**Board of Adjustment
Special Meeting Agenda
Fraser Town Hall, 153 Fraser Avenue
Wednesday February 26, 2025
5:30 PM - 6:30 PM**

a. Appeal Of Administrative Variance Denial - The Ascent

MAJOR SITE PLAN
THE ASCENT

RE: The Ascent – Final Plat, Major Site Plan, Administrative Variance
Planning Review Comments (1st Referral Review)

SITE PLAN
January 29, 2025
SHEET 2

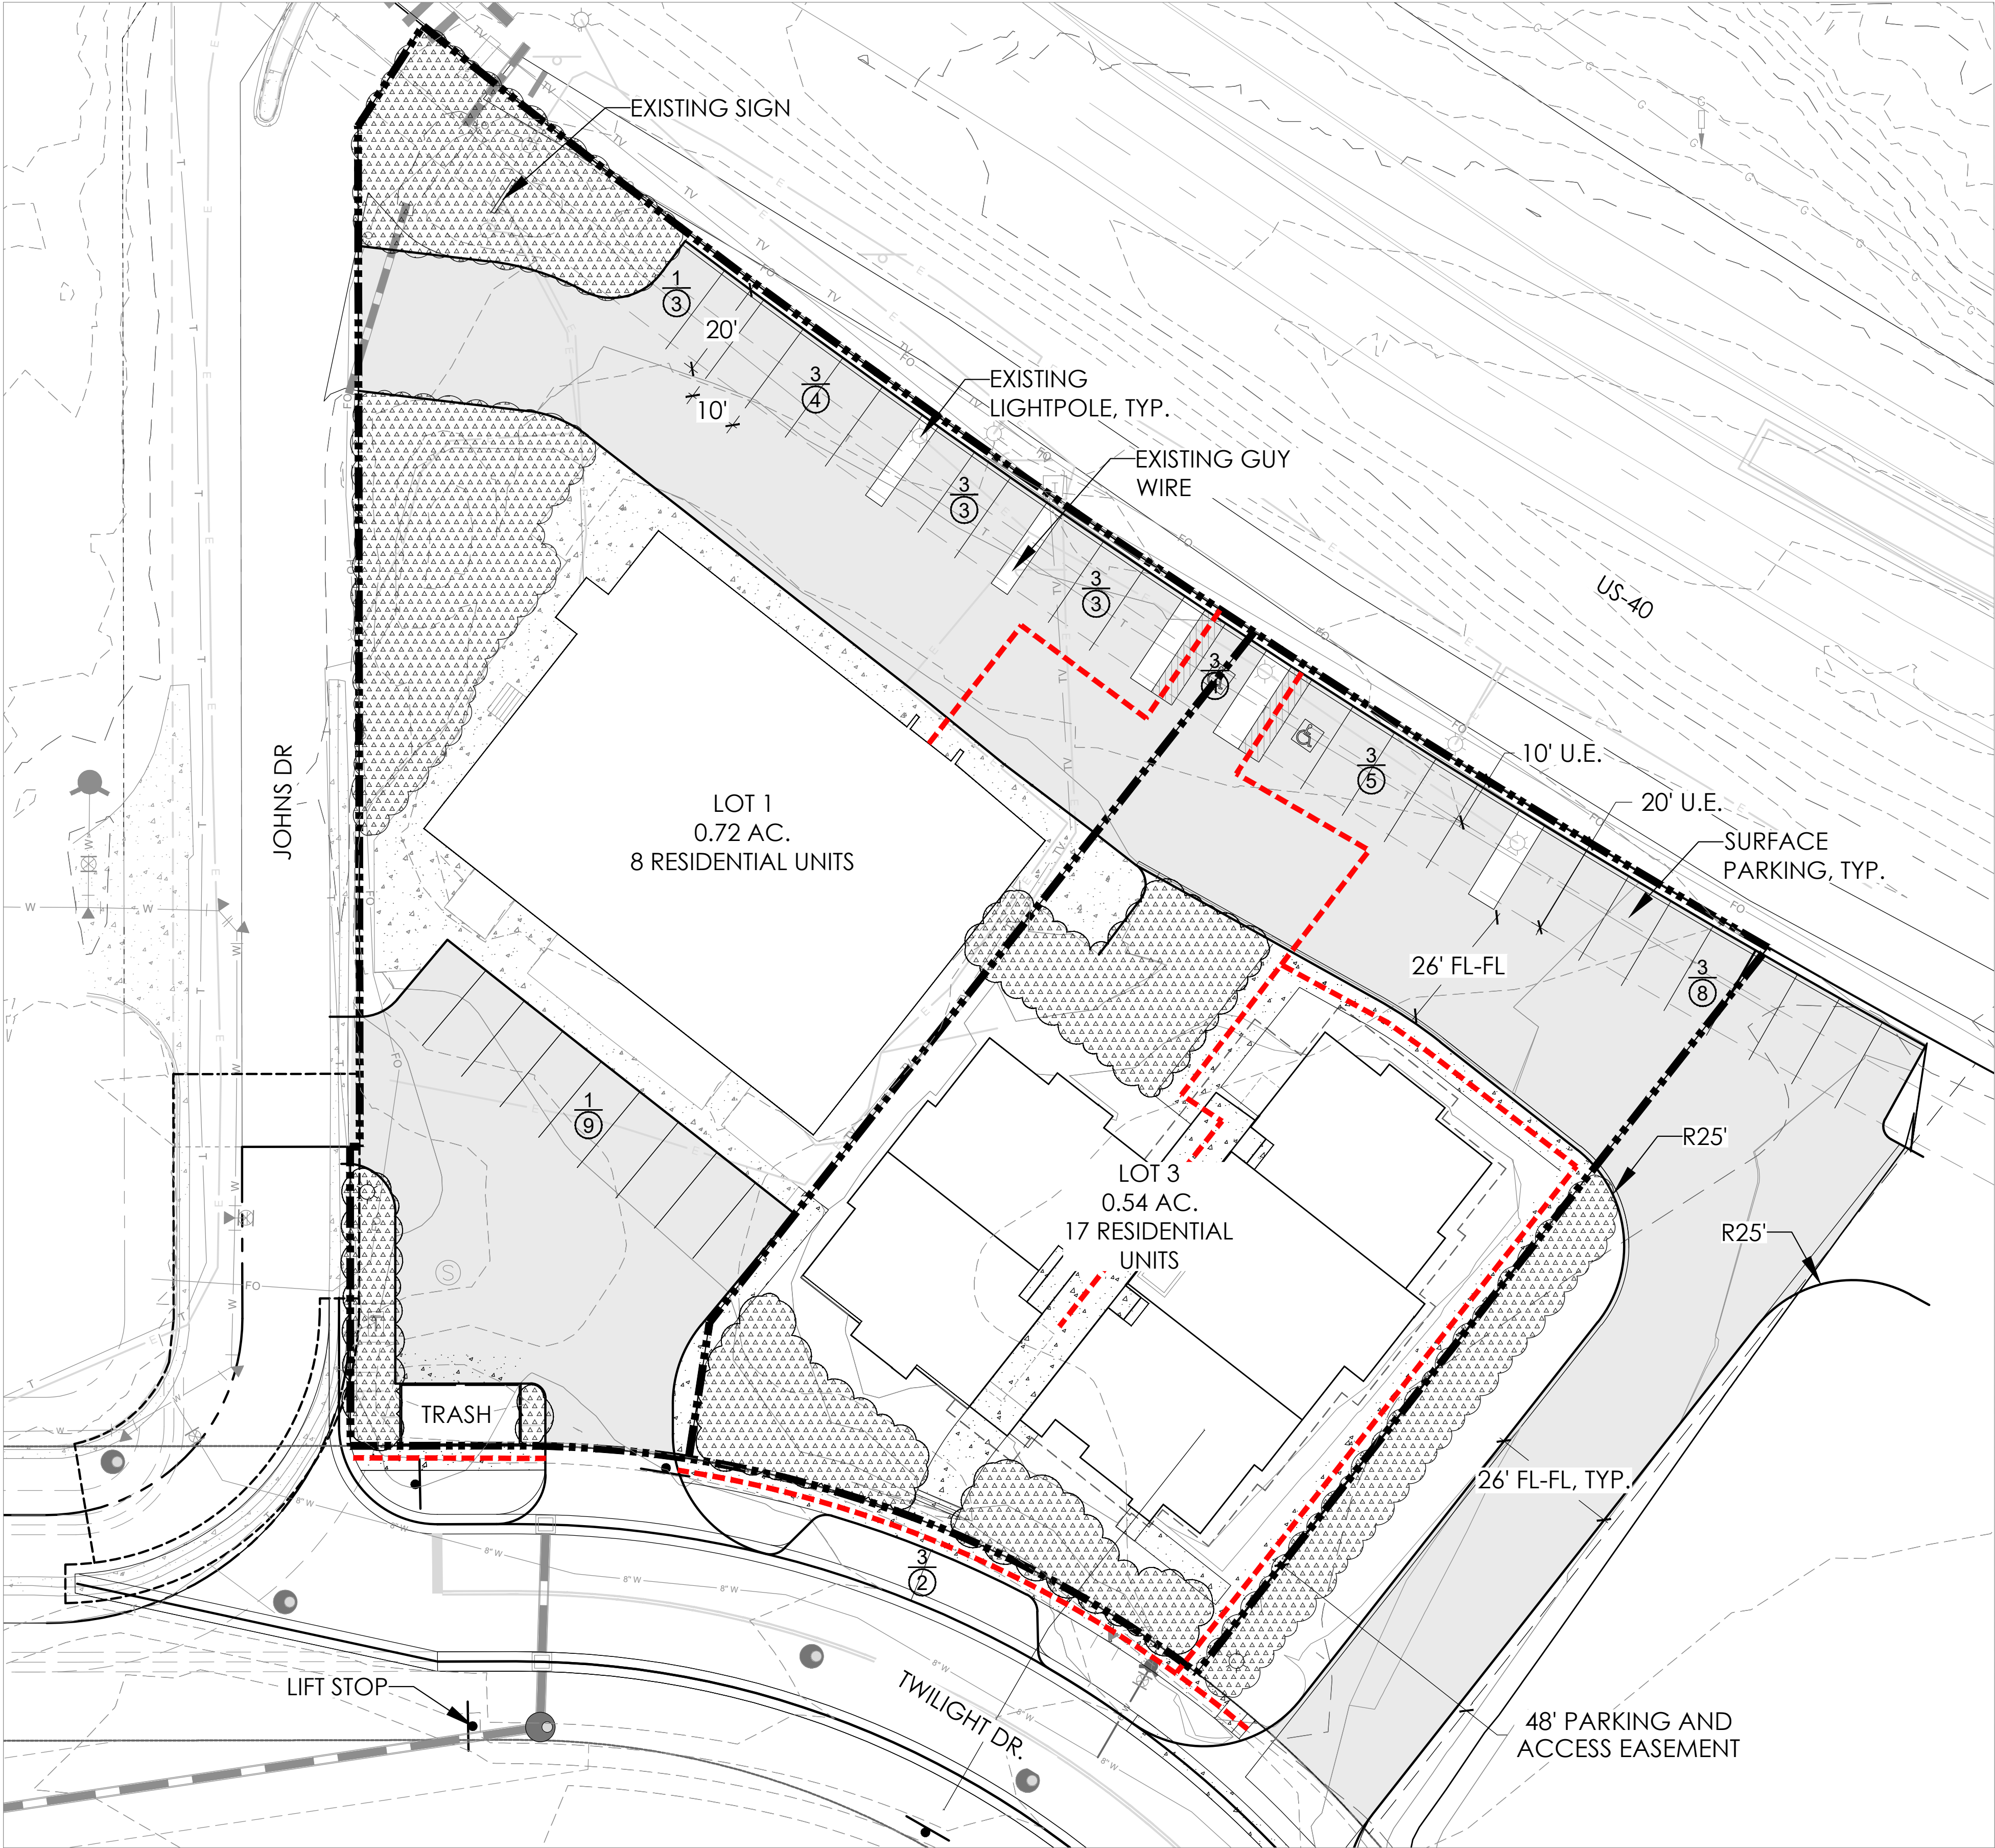
Sheet 2 – Site Plan

- 24) Provide a trash enclosure detail showing conformance with [Sec. 19-4-160\(b\)](#), i.e., label the enclosure color and materials to ensure they are consistent with those of the main building.

- 25) Include a summary of unit types by bedroom count or note that all units will be two-bedroom units.
- 26) Note or provide in the data table the number of bedrooms in the existing two units in the XSports building since there will be shared parking between the lots.

- 28) Please add a note that the two parallel spaces proposed along “Victory Rd” within the proposed ROW are included in the provided parking count.
- 29) Data table lists Lot 1A and 2B. Should be 1A and 1B unless the lots are renumbered to Lot 1 and Lot 3 as requested by staff.

- 30) Please remove floor plan linework from building footprints for clarity.
- 31) In September 2024, the Town adopted by reference the 2023 Colorado Model Electric Ready and Solar Ready Code. The site plan must display compliance with applicable requirements of this code before building permits are issued. Please designate on the parking plan at least a minimum number of EV spaces per the requirements below. Definitions for each category of EV capability are found in Chapter 2 of the referenced code. Multifamily residential is found on page 25 and must include the following:

LANDSCAPE PLAN

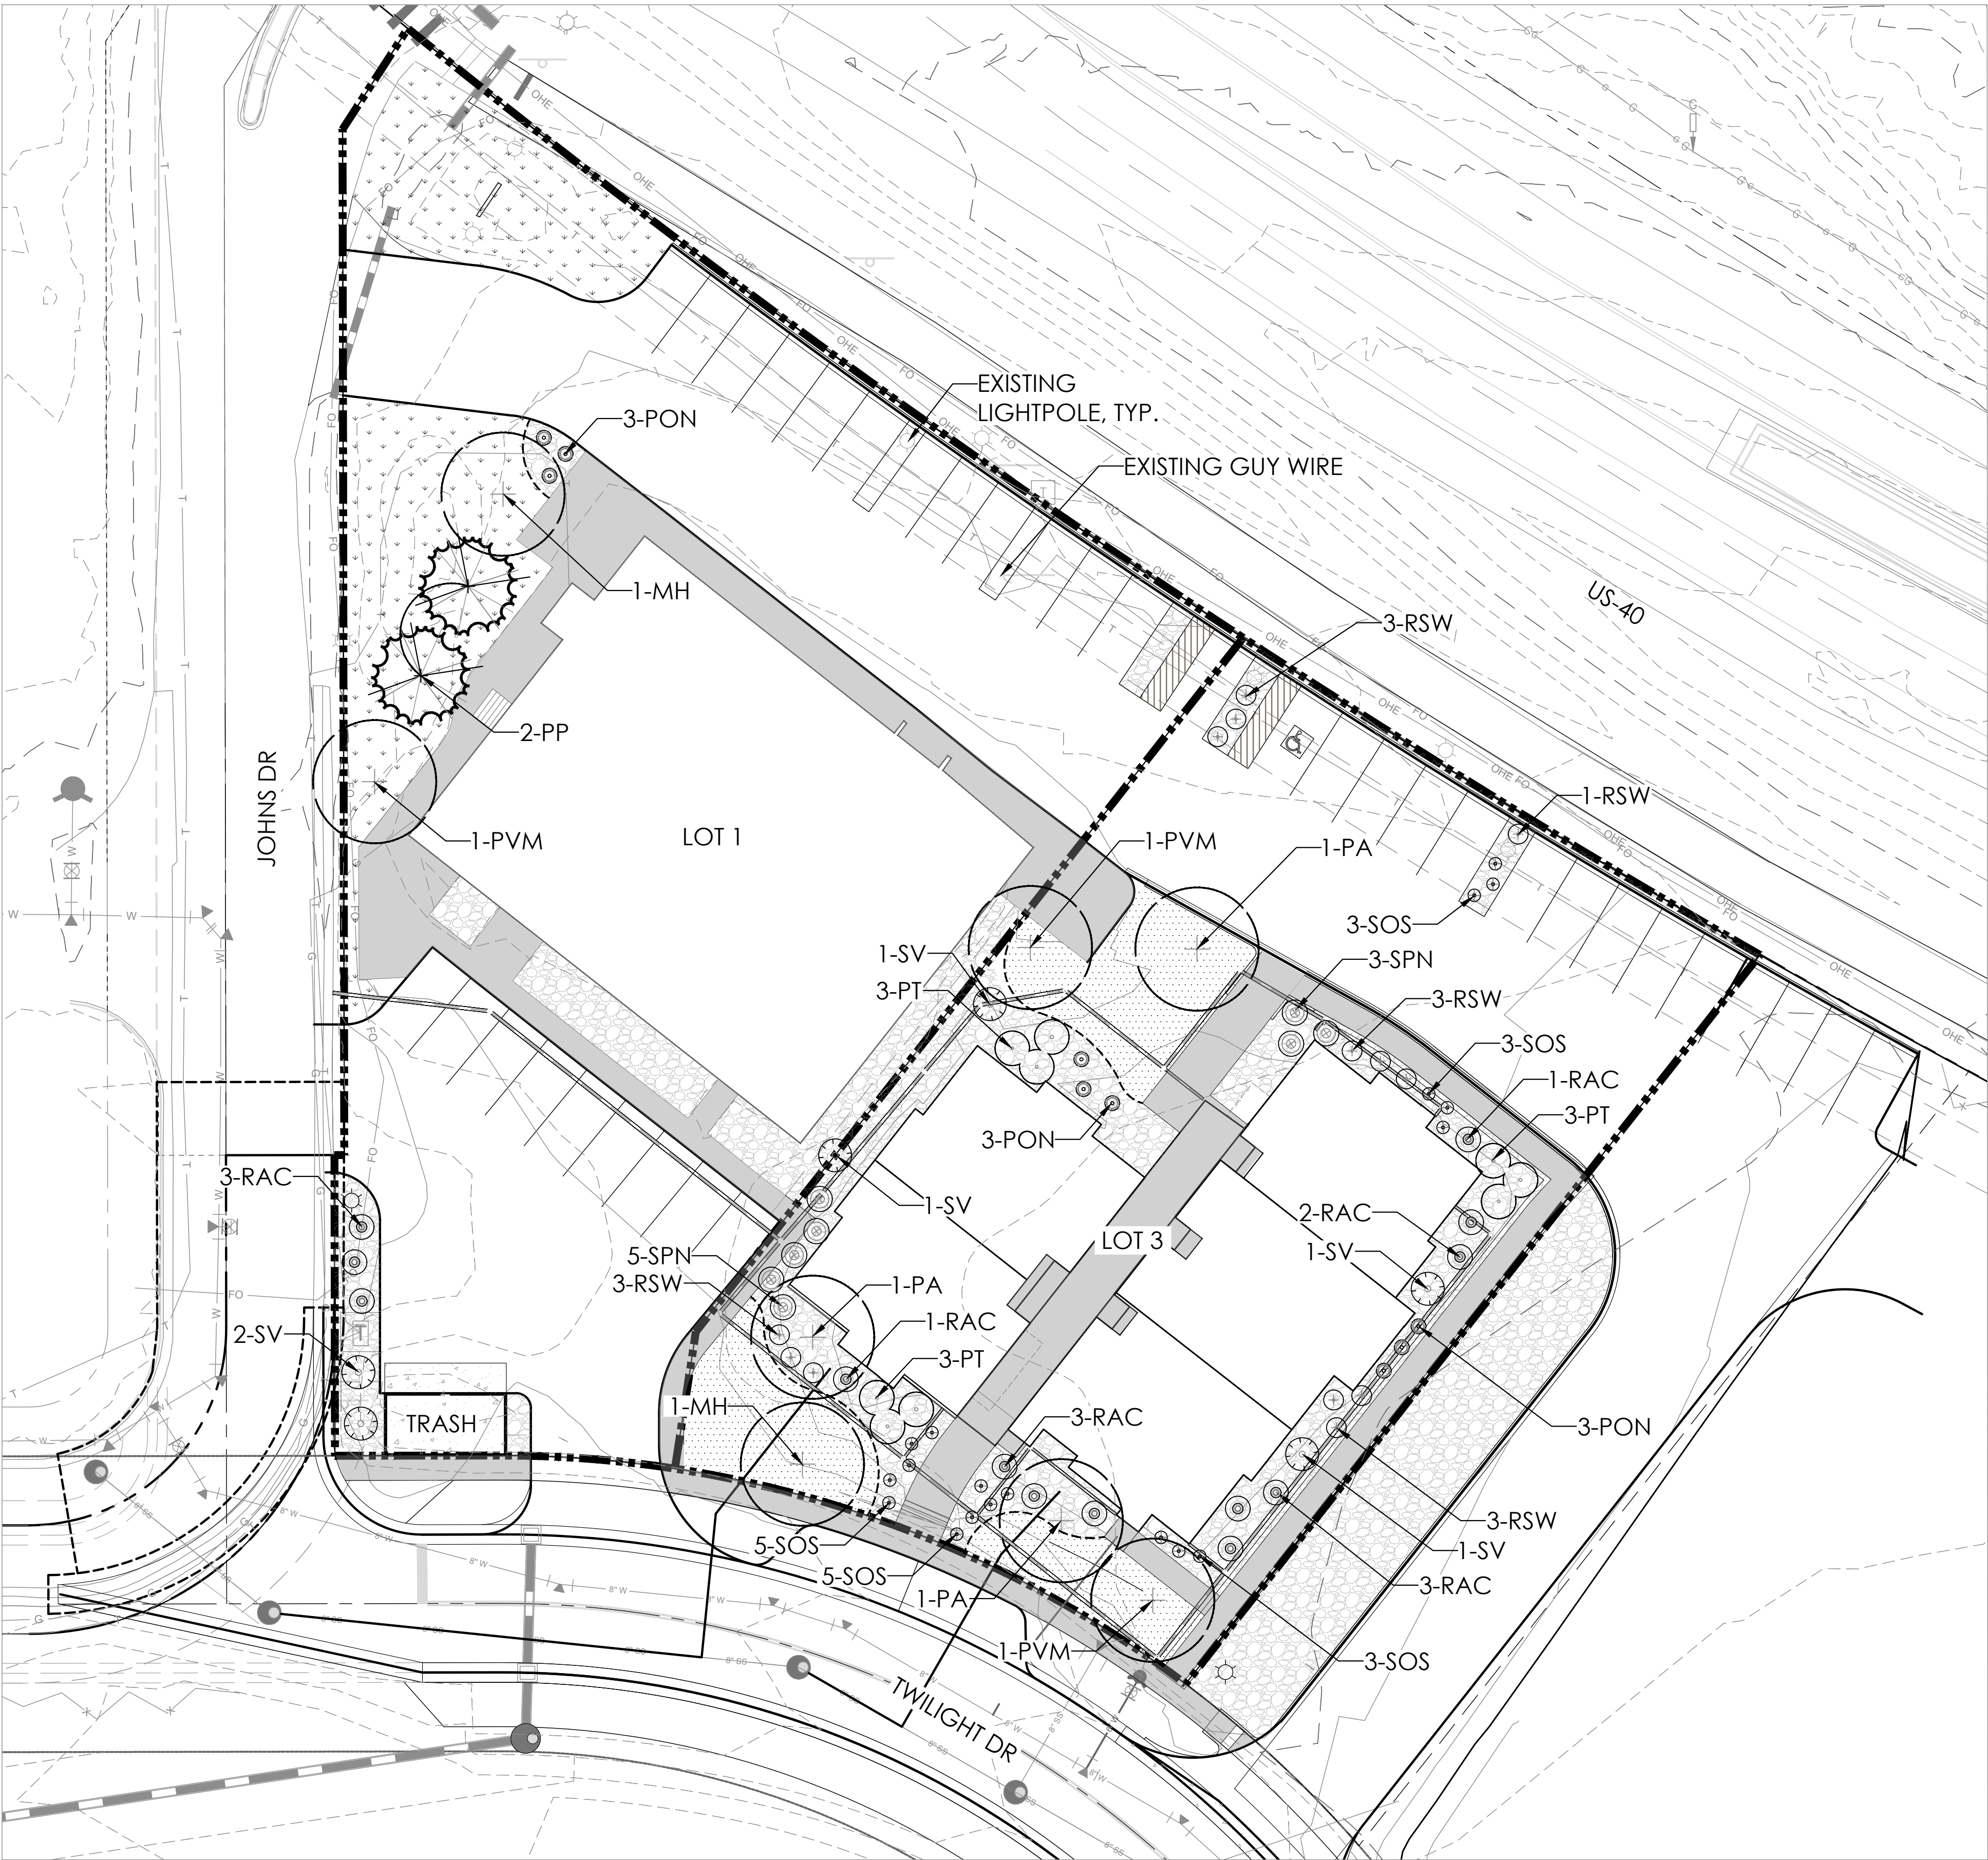
Sheet 3 – Landscape Plan

- 34) [Sec. 14-5-40\(10\)](#) requires parking lot interior landscaping islands for parking lots with twenty (20) or more parking spaces at a ratio of one hundred (100) square feet and one (1) tree and two (2) shrubs for every ten (10) parking spaces. Please provide additional interior landscaped islands within the parking area on the northeast side of the site, similar to the two that are proposed at either end of the southeast row of parking.

- 35) Provide the following as required in [Sec. 14-5-40](#) - landscaping specifications:
- Provide an irrigation plan, if irrigation is to be provided.

- Include a statement providing that the owner and his or her heirs, successors and assigns will provide adequate maintenance for all site elements. Landscaping maintenance shall include irrigation, fertilization, pruning and noxious weed control.

- Include contact information on who prepared the landscape design. A landscape plan drawn by a landscape architect or designer is preferred but is not required.

- 36) Please provide a cost estimate of the proposed landscaping subject to the following requirement from [Sec. 14-5-40\(11\)](#). This amount will need to be included in the collateral collected as part of the DIA:
